Subject: 1 Yachtview Avenue, Newport DA 2021/0395 WRITTEN SUBMISSION:
LETTER OF OBJECTION Submission: Howard

S U B M I S S I O N : H O W A R D
a written submission by way of objection to DA 2021/0395

Re:
1 Yachtview Avenue, Newport
DA 2021/0395

Alterations & Additions to a Dwelling

A4 Localities: Newport Locality

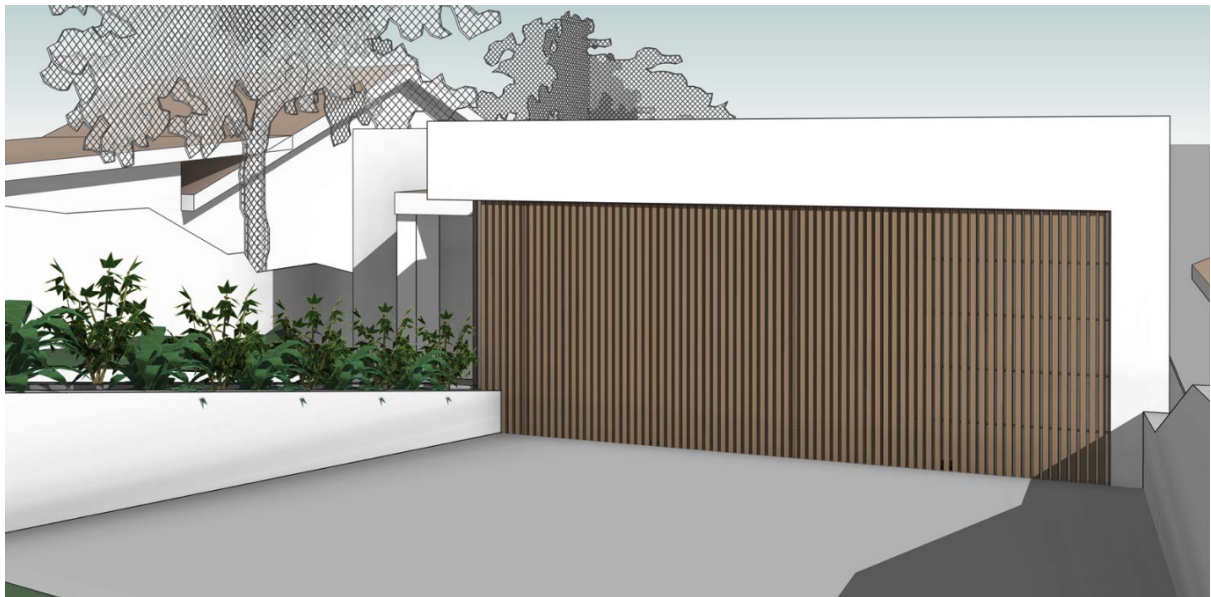
Proposed development built with zero front setback is not in keeping with the desired character of the E4 Zone.

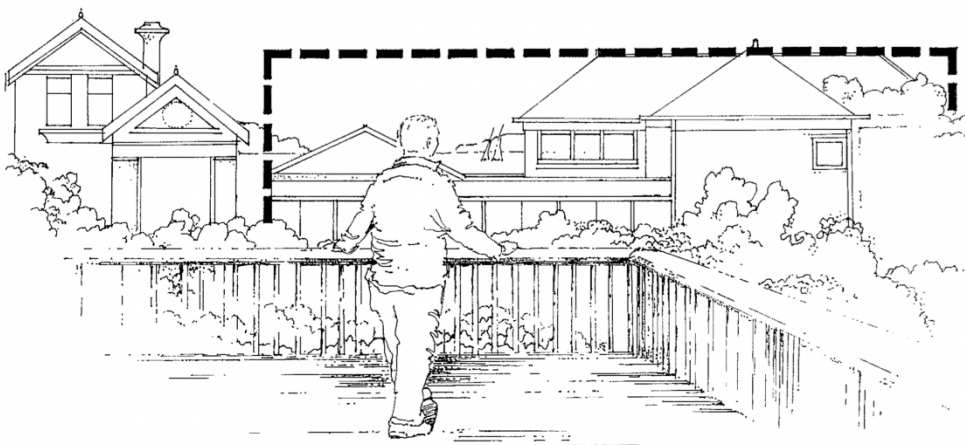
As the proposed development does not comply with outcomes and controls, that are the most relevant to visual impacts, greater weight would be attributed to the effects caused.

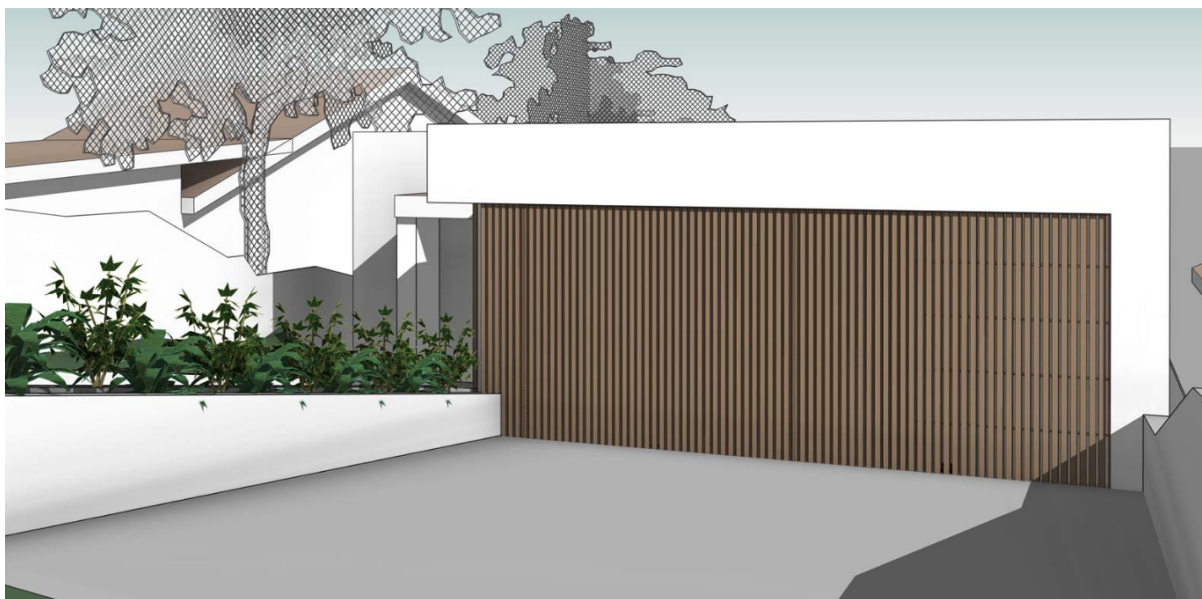
Garages, carports and other parking structures including hardstand areas must not be the dominant site feature when viewed from a public place.

Except in the Newport Commercial centre, parking structures must be located behind the front building line, preferably set back further than the primary building, and be no greater in width than 50% of the lot frontage, or 7.5 metres, whichever is the lesser.
